Manual Amendment - 36032

Amendments to Schedule A – Part One in Manual 36:

1. Amend Article 8 – Use of Motorsport Vehicles on Public Roads as stated below.

Diagram 8.3 (6) (d)

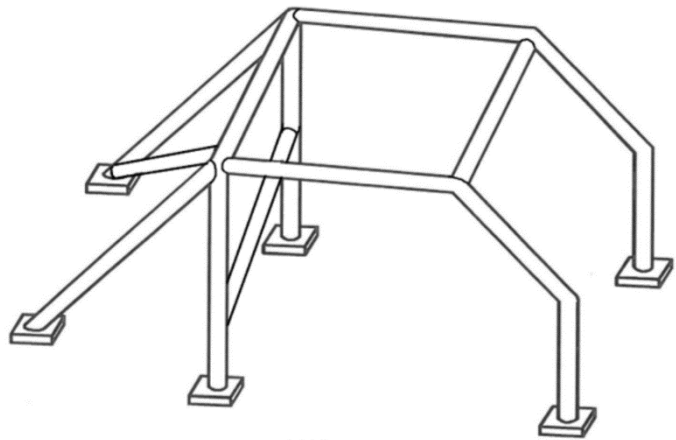
- (d) **Removal of a Manufacturer Occupant Protection System (MOPS):** from a vehicle (primarily used for motor sport competitions) may be authorised under the Authority Card system. The vehicle shall be fitted with and comply with the following:

- (ii) At a minimum, a full Safety Cage, in compliance with Schedule A, Part One, Article 4.6 and Part Two, Article 5.1 through 5.5 as per diagrams 8.3(6)(d) below. ~~incorporating forward reinforcements (terminating at a substantial structure such as the suspension strut tower) in full compliance with this Schedule; and~~

Reason: *To align motorsport requirements with updated LVVTA procedures for MOPS Removal.*
